**Information Response for MCU Mixed Development
At 49 Macrossan Street, Port Douglas (Planning Act)**

I refer to Council's confirmation notice of 16 October 2017 and the Information Request of 18 October 2017. I am pleased to provide you with the information response for the above described application in accordance with section 13.2(b) of the Development Assessment Rules and Council may now proceed with its assessment of the application.

Vehicle Swept Paths

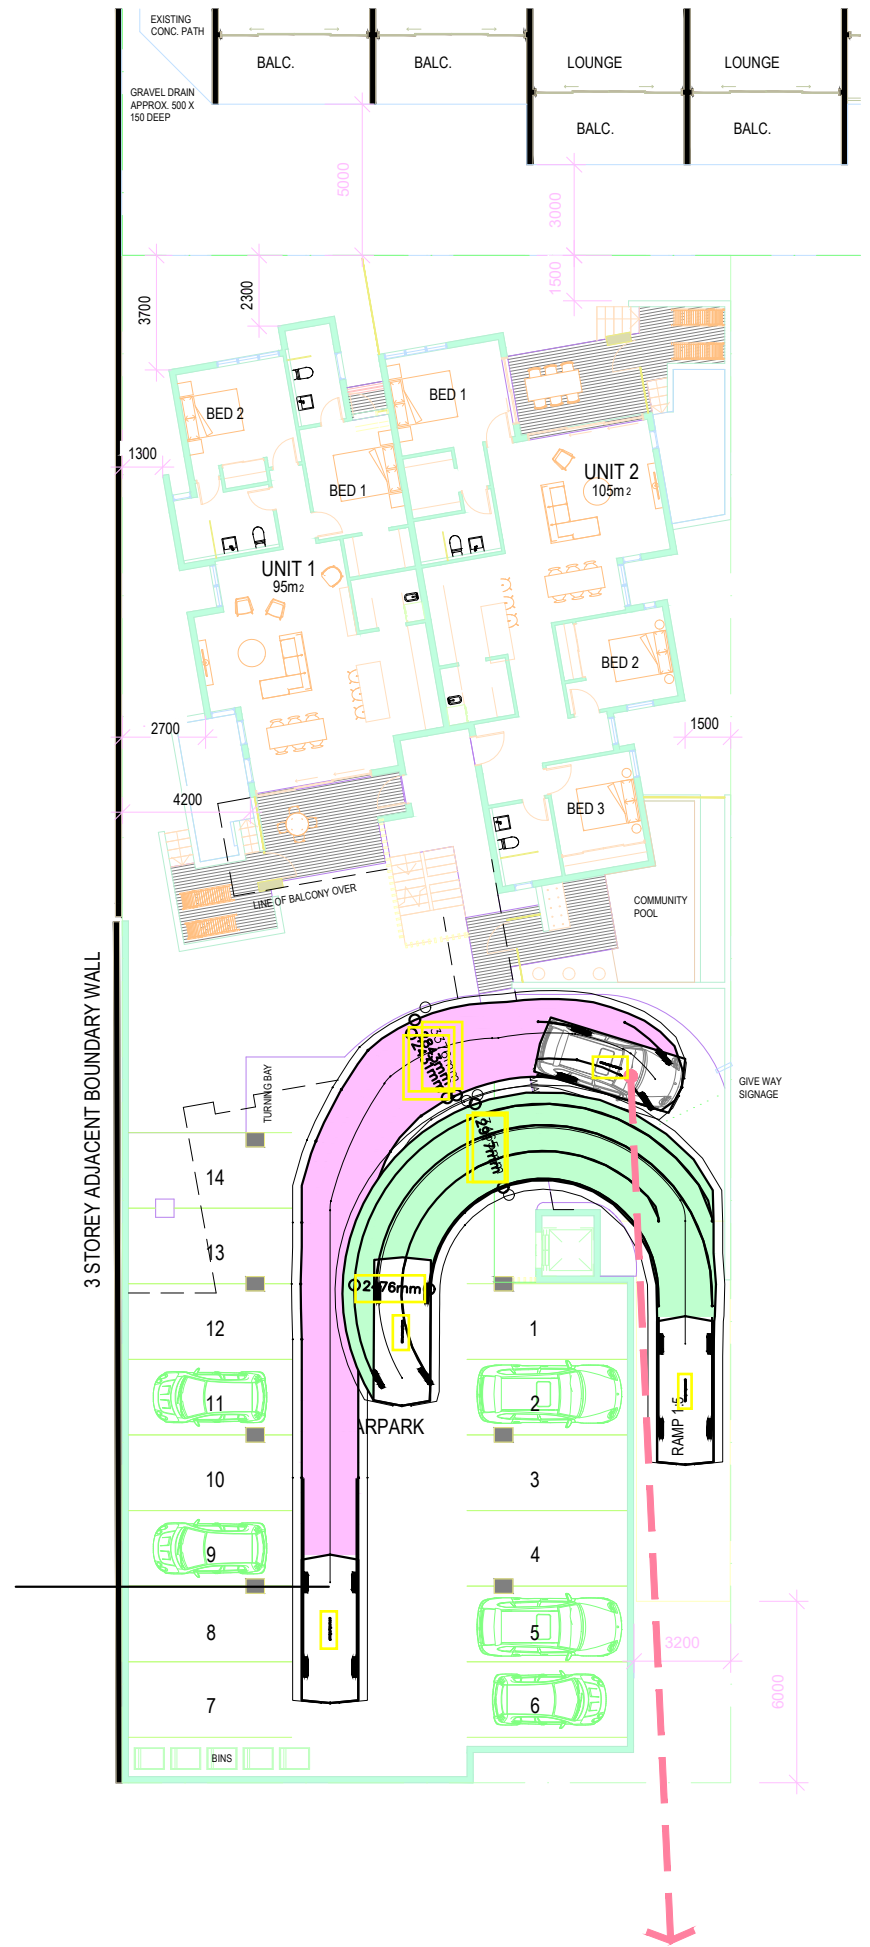
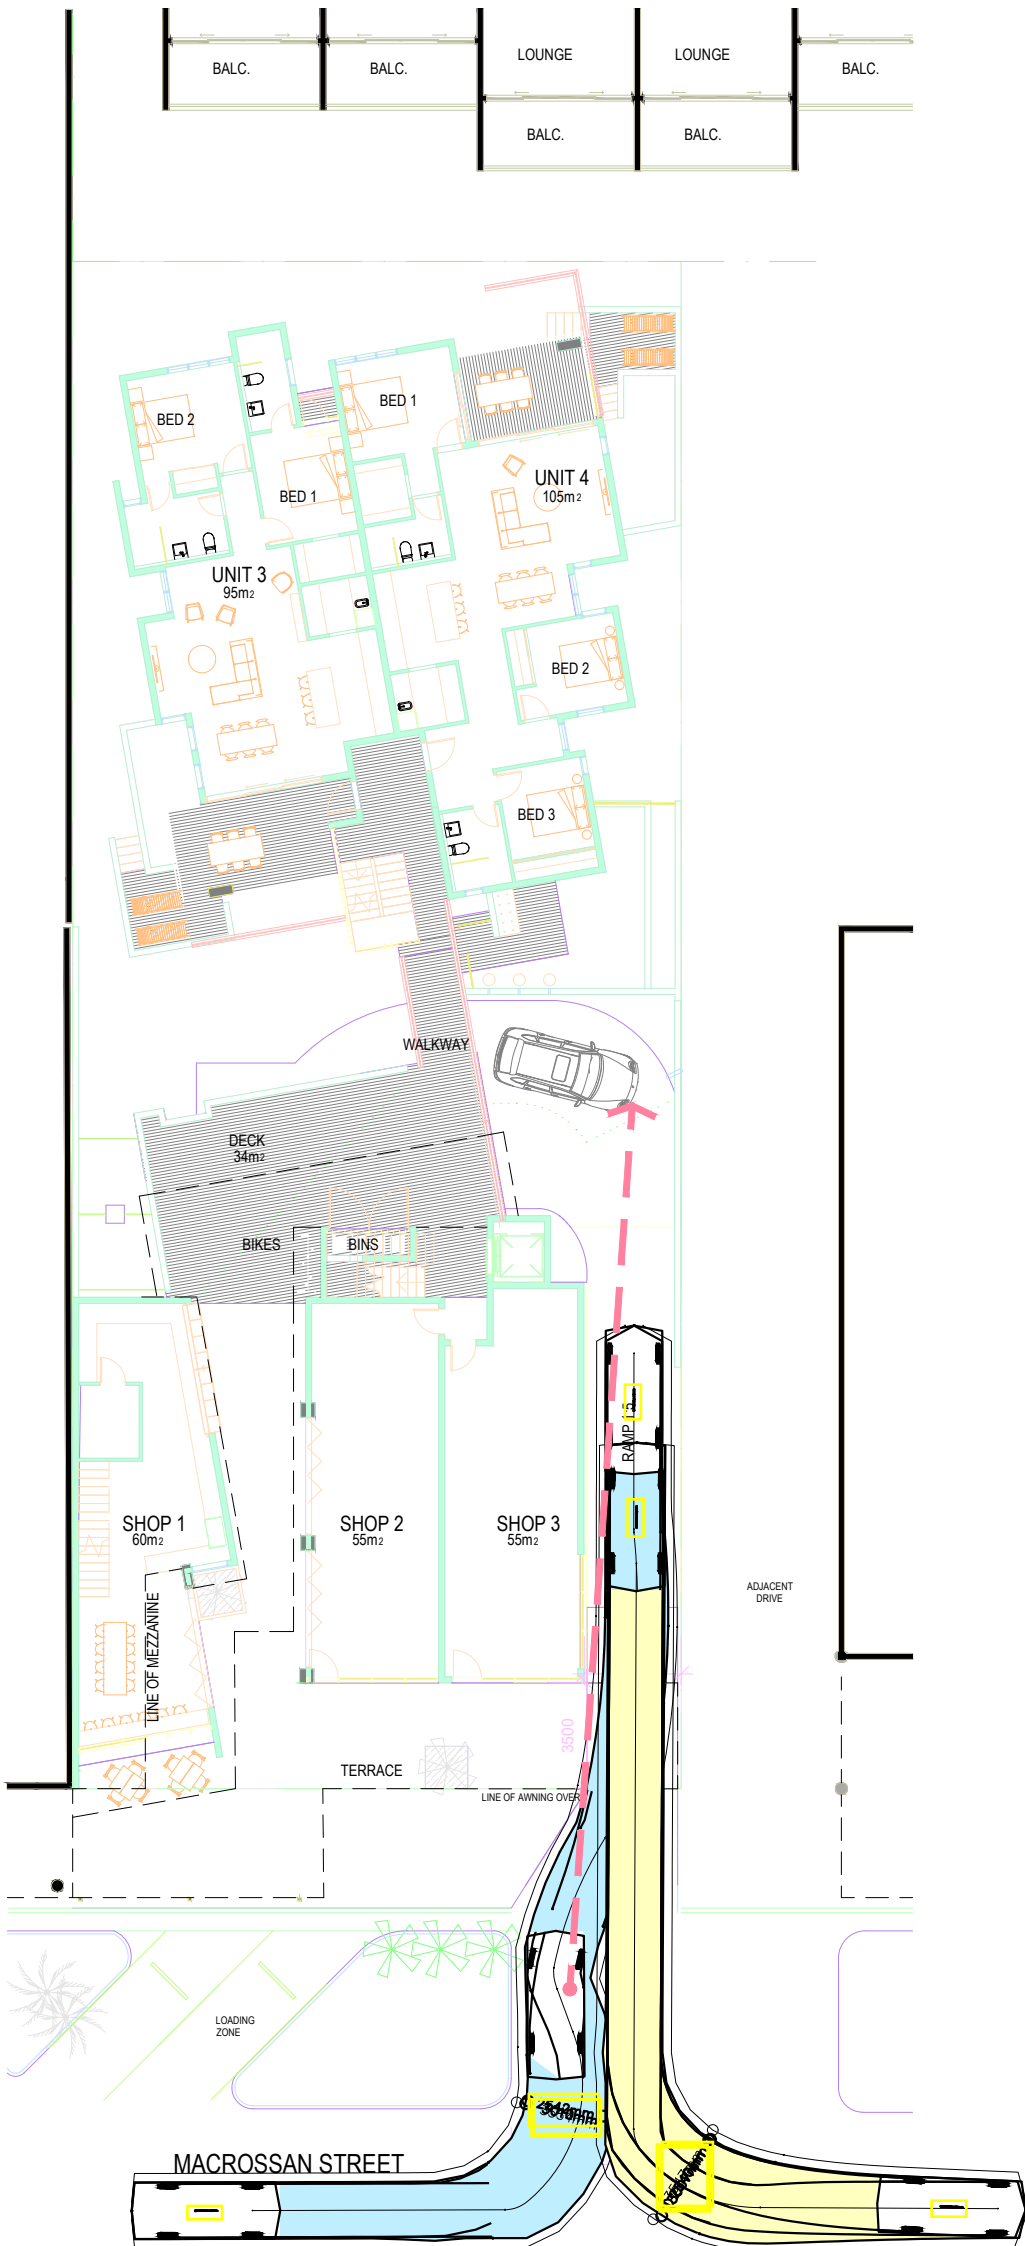
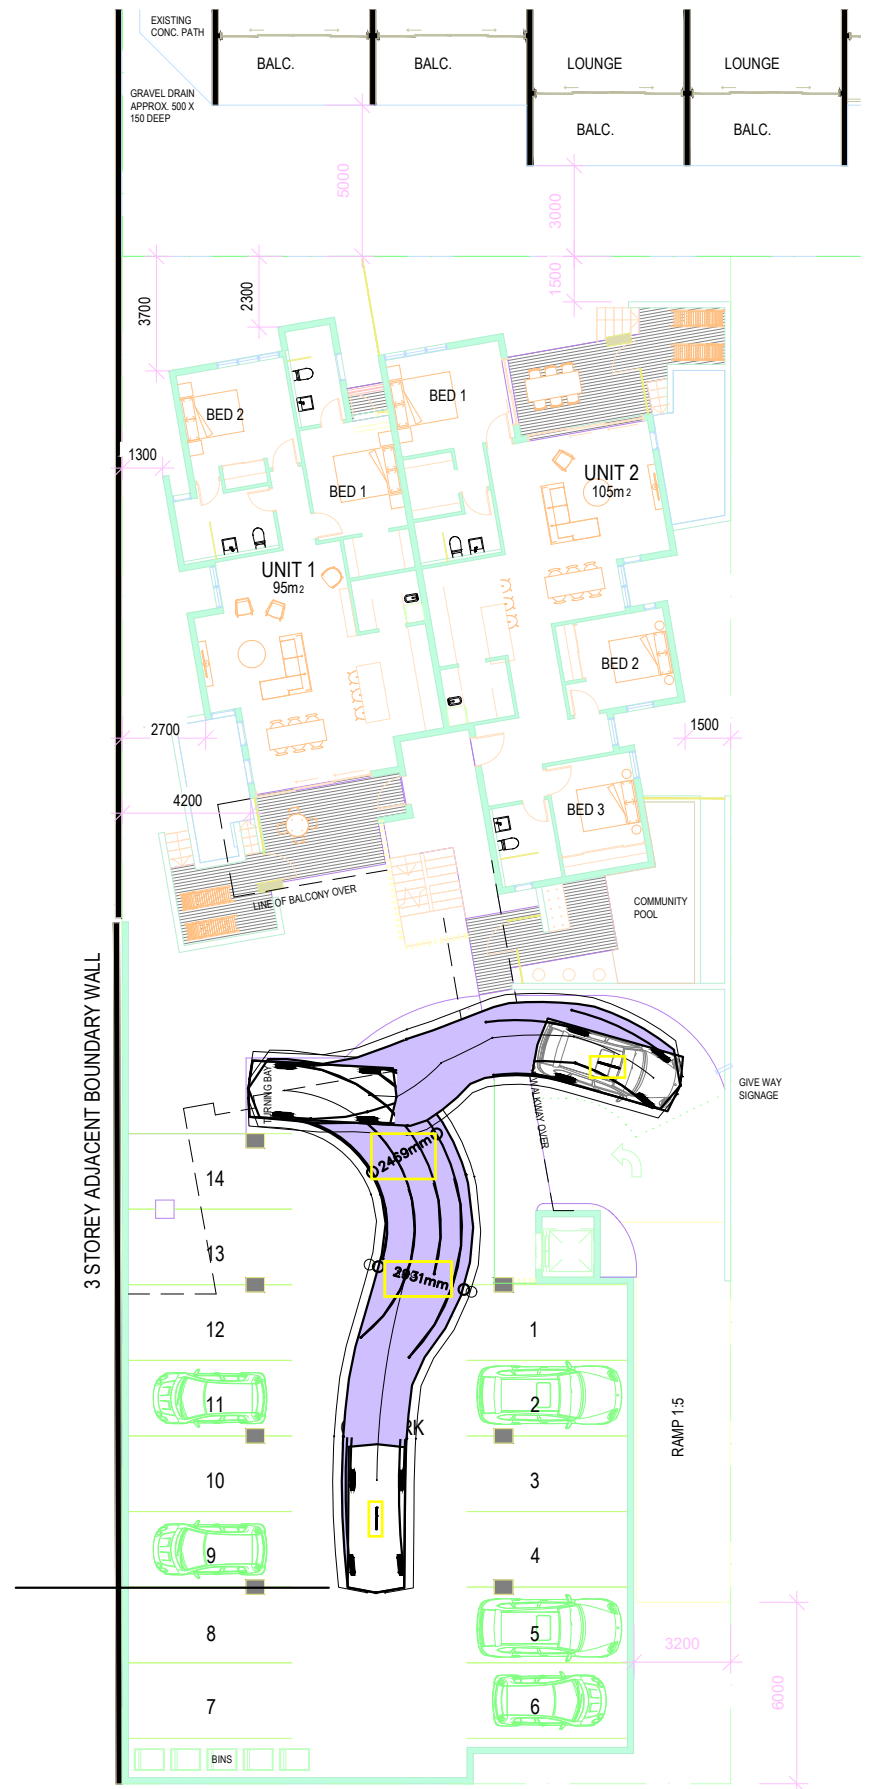
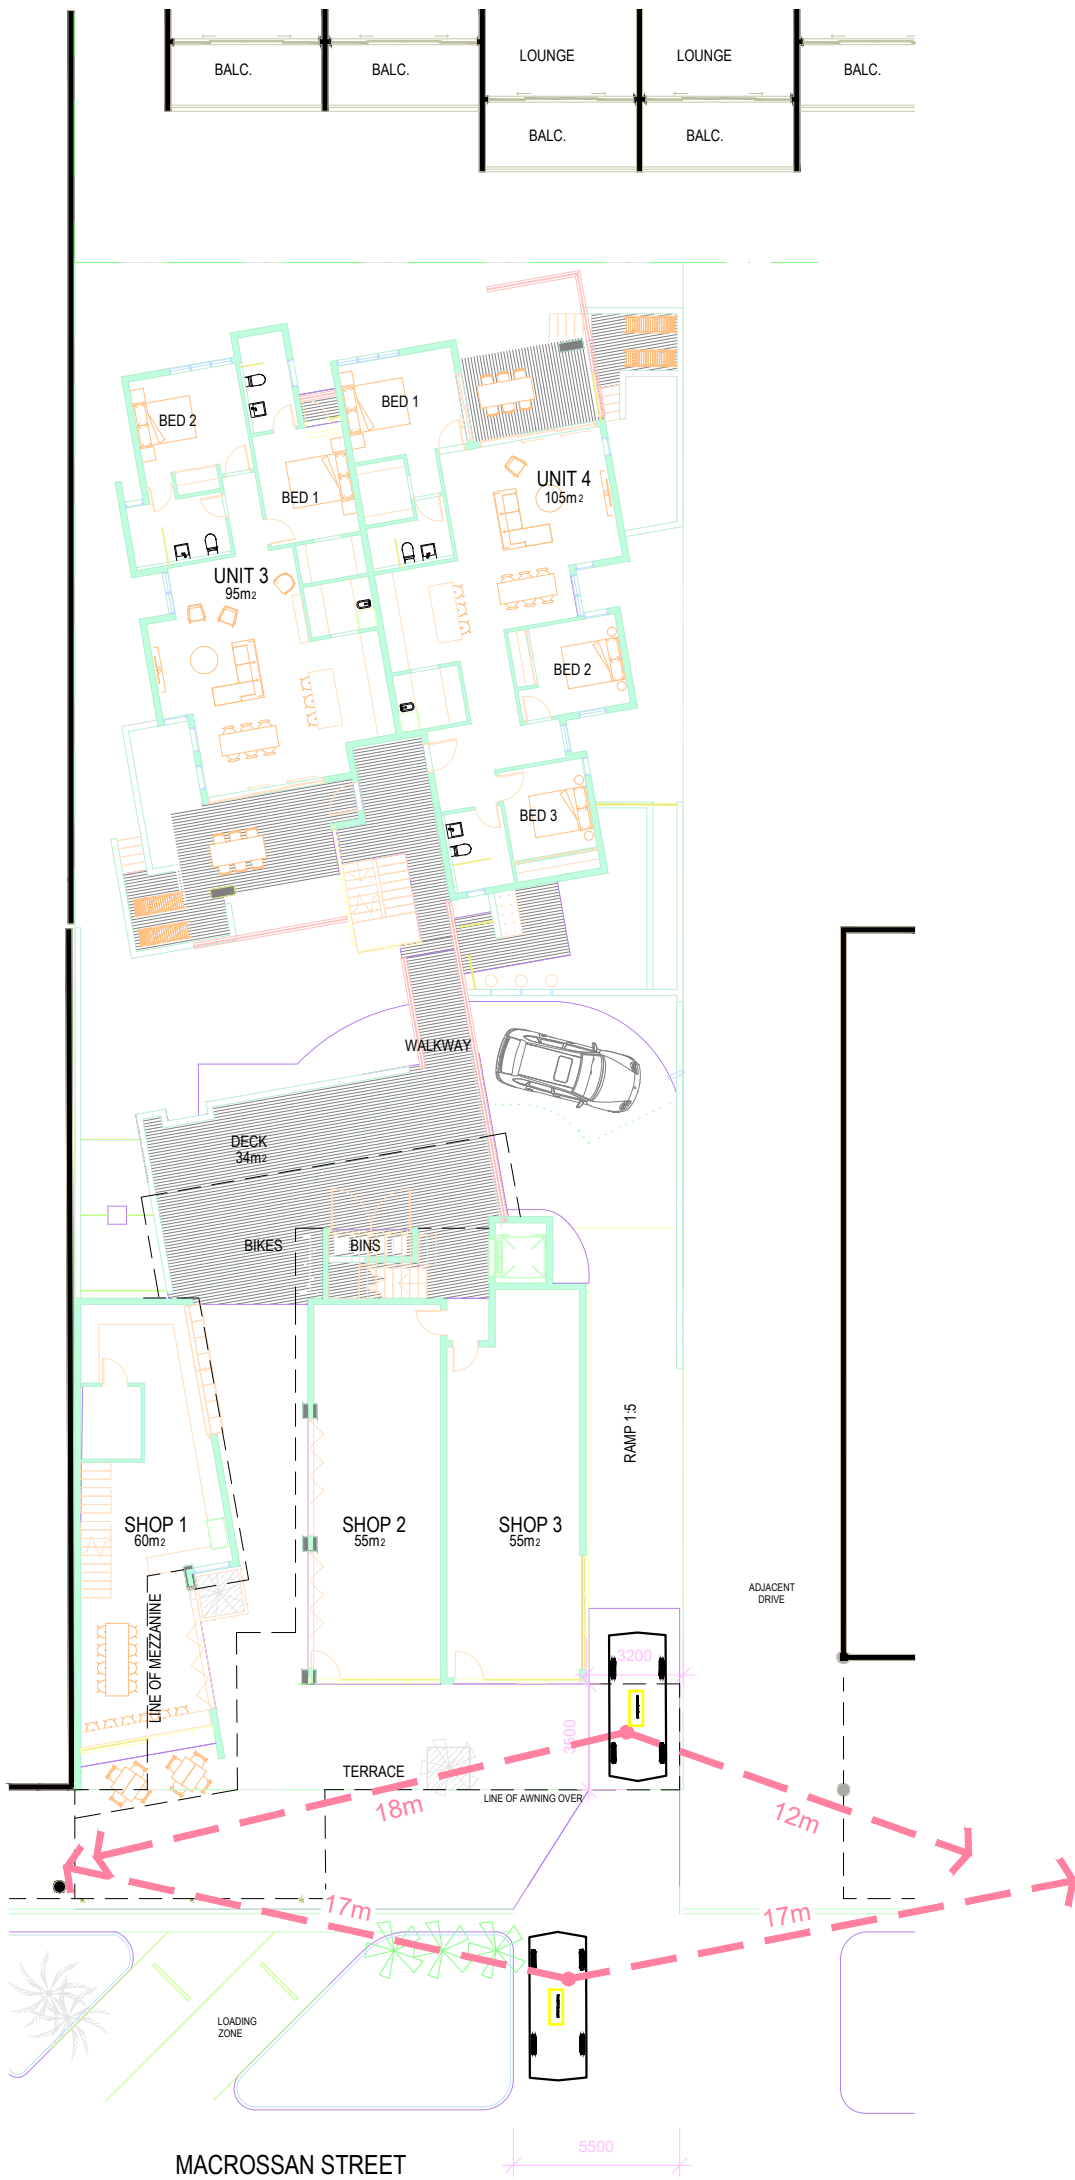
3.1 Provide a report by a qualified RPEQ Engineer regarding the vehicle access to the basement car parking area and the pedestrian access movements.

CMG Engineers Report (ref 38807R1) is attached. The report demonstrates the geometry of the driveway, parking and layby areas, together with the vehicle sweep paths allows:

1. Sufficient site distance is provided between the basement and the layby area.
2. Adequate site distance with respect to vehicles entering and exiting the site as well as pedestrian movements.
3. All vehicles to enter and exit the site in a forward manner. The traffic management configuration will not result in any vehicles reversing up or down the access ramp.
4. A turning bay in the basement carpark.

1. Sufficient site distance is provided between the basement and the layby area.
2. In this low speed environment there is adequate site distance with respect to vehicles entering and exiting the site as well as pedestrian movements.
3. The traffic management configuration will not result in any vehicles reversing up or down the access ramp. All vehicles will enter and exit the site in a forward manner.
4. A turning bay is also provided in the basement carpark as shown on the attached sweep paths drawings.
